CEPC CHESTER TERRACE

FOR COMMENT

**BALUSTRADE
DECONSTRUCTION
SHEET 2**

24509/SK12

CROSS SECTION SHOWING
DECONSTRUCTION OF
BALUSTRADE

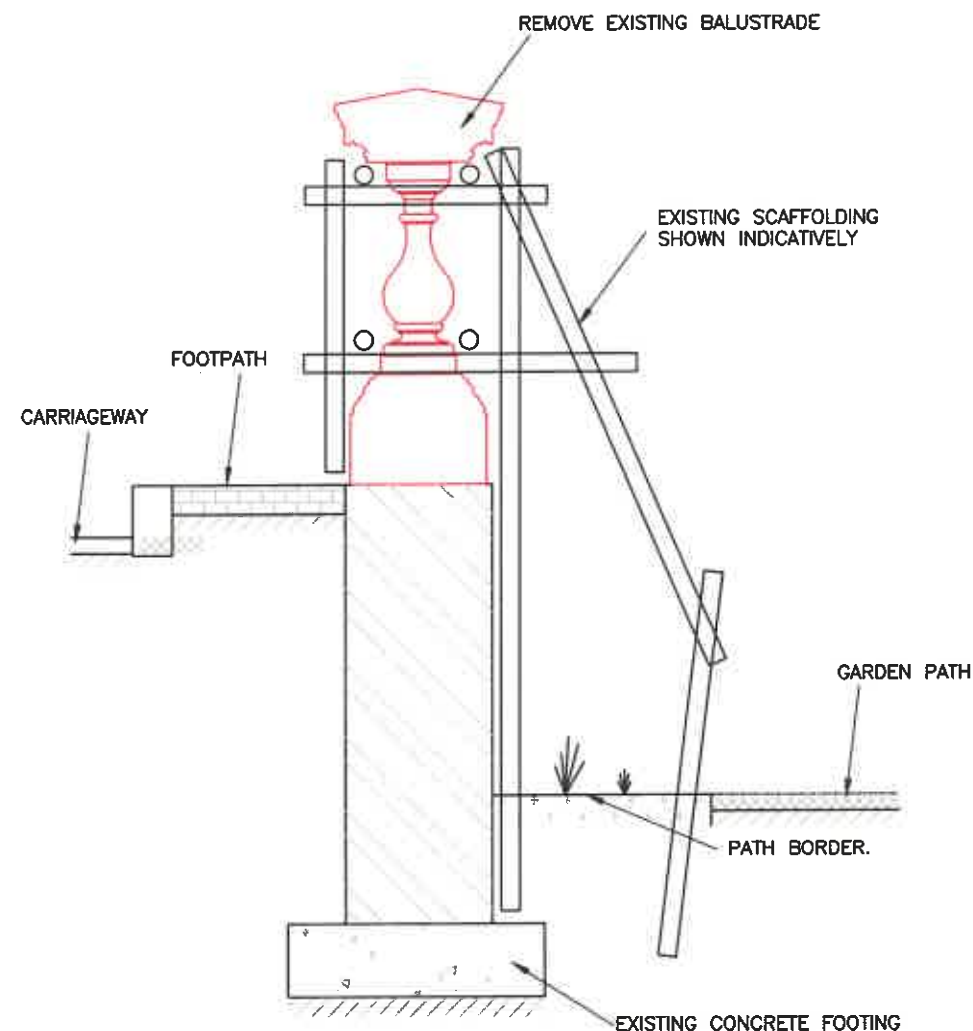
- 1) Do we want to do the analysis on the work section?
- 2) Do we want to lift the parapet?
- 3) why such a long section?
